JWH Consulting

Report to
Energy Consumers Australia

Advice on the Capex Portion of the AER's Revenue Determination for TransGrid

2 January 2018

Figure 1: AusGrid's Historic Base Forecast for Inner Sydney

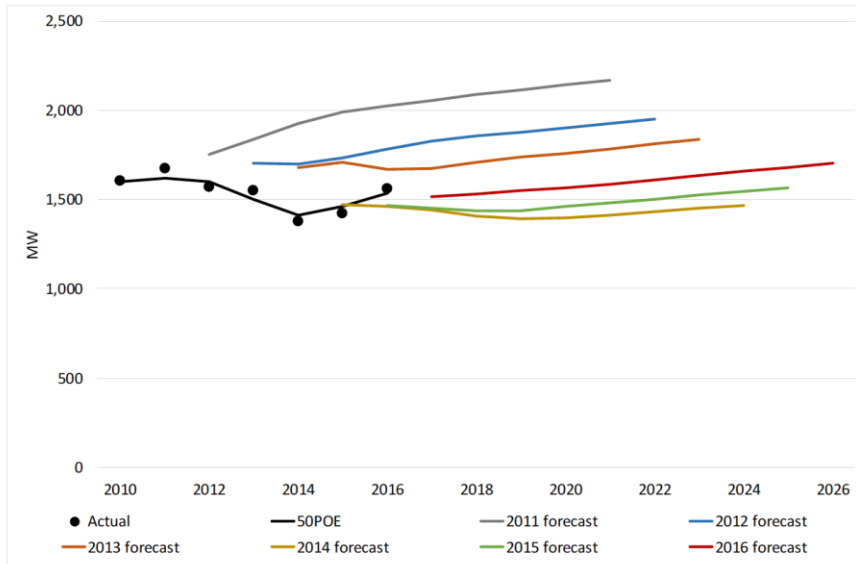
The GHD report attached to the TransGrid proposal has two charts that show the past performance of the AusGrid forecasts for inner Sydney, Figure 1, and the makeup of the AusGrid 2016 development forecast, Figure 2. The first figure shows the base forecasts and not development forecasts. It shows that the forecasts prior to 2014 were similar to other forecasters over this period, perhaps even worse than some, and then they were improved significantly. These forecasts would appear reasonable.

Figure 2: AusGrid's 2016 Developmental Forecast and Constituent Parts

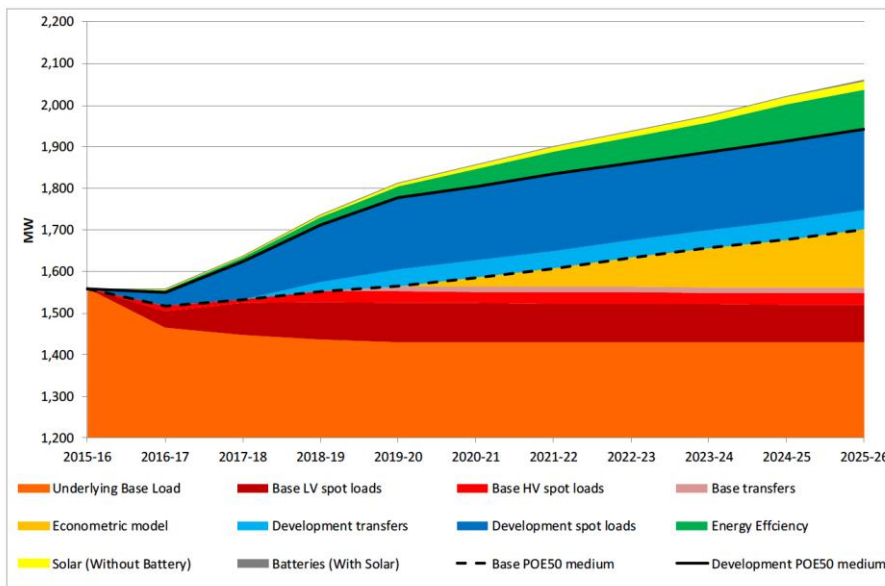
However, it is the development forecast in Figure 2 which has been used in the regulatory Investment Test for Transmission (RIT-T) for PSF. There is a 200MW increase over the base forecast by 2019/20 which is massive; effectively a 6.5% annual growth rate. Most of the new buildings have a 5 star NABERS rating compared to the old stock which would be 2 or 3 star rated and the estimated reduction in energy cost going from a 2 star building to a 5 star building is about 55%⁸. This would imply that there is significant growth, well in excess of the already high 6.5% in order to get the demand change predicted.

Figure 3: City of Sydney: GHG Emissions Past and Forecast⁹

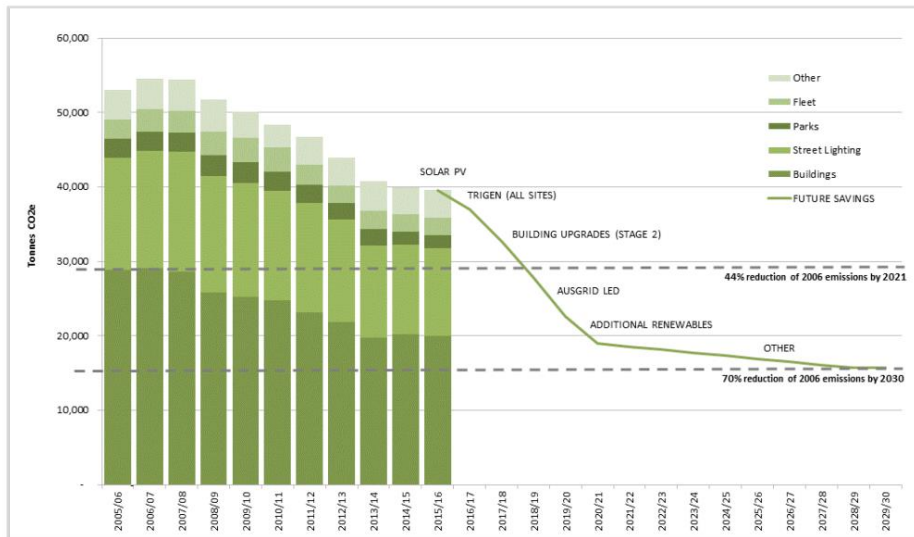
There is a significant change occurring in high rise building energy efficiency around the country at present in terms of building design and retro-fitting of trigeneration and other measures. For example, the City of Sydney established the Sustainable Sydney 2030 program in 2008 and one of the targets was to reduce the Green House Gas (GHG) emissions by 70% by 2030 in the City of Sydney. A large part of that reduction is to come from projects such as the mandatory NABERS ratings of all commercial building and the promotion of trigeneration for upgrading the efficiency of buildings. Figure 1 shows the past and forecast GHG emissions taken from the statutory GHG reporting and future programs. It can be seen that a 26% reduction has already been achieved and further programs are forecast to cut the levels further. The results achieved so far are with a background of growth in the Sydney CBD and surrounds. This does not appear to be adequately factored into the demand forecasts of AusGrid.
